Architectural Commission Report

Meeting Date: Wednesday, December 17, 2014

Subject: **ISAIA (PL1431910)**
9533 Brighton Way
Request for approval of a construction barricade graphic. The Commission will also consider adoption of a Categorical Exemption, pursuant to the California Environmental Quality Act.

BARRICADE
SECONDARY ELEVATIONS

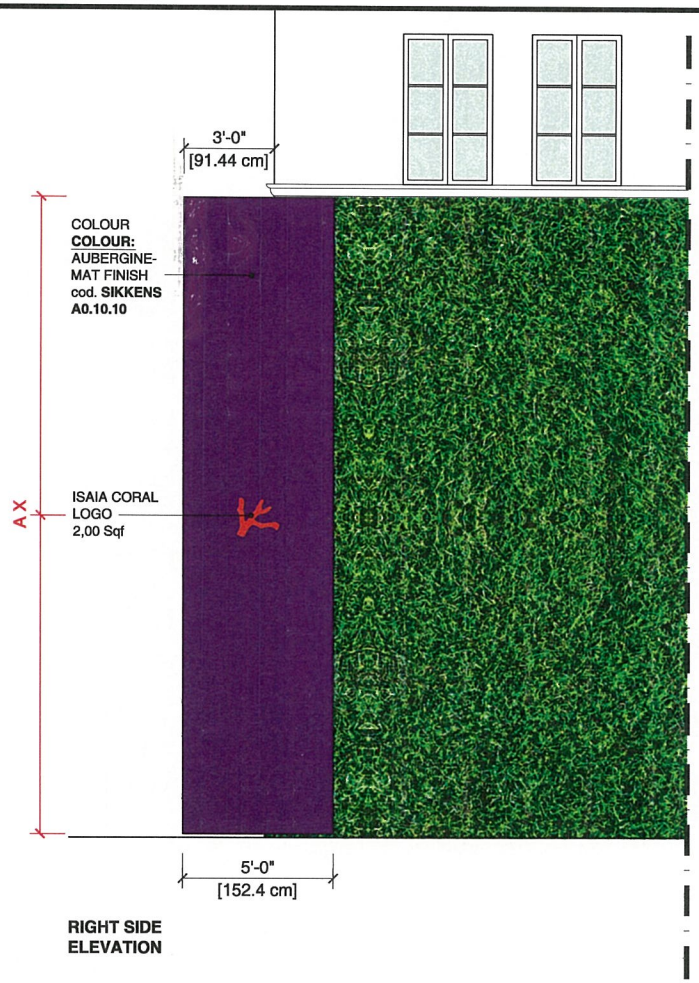
However, the barricade returns are not consistent with the Community Development Department's policy of requiring 6 SF of sign area on the barricade returns to be allocated to adjacent tenants. A condition of approval has been added to provide this signage.

1. Each construction barricade return shall provide for a six square foot (6 SF) space allocated to immediately adjacent tenants to indicate that their stores remain open during construction.
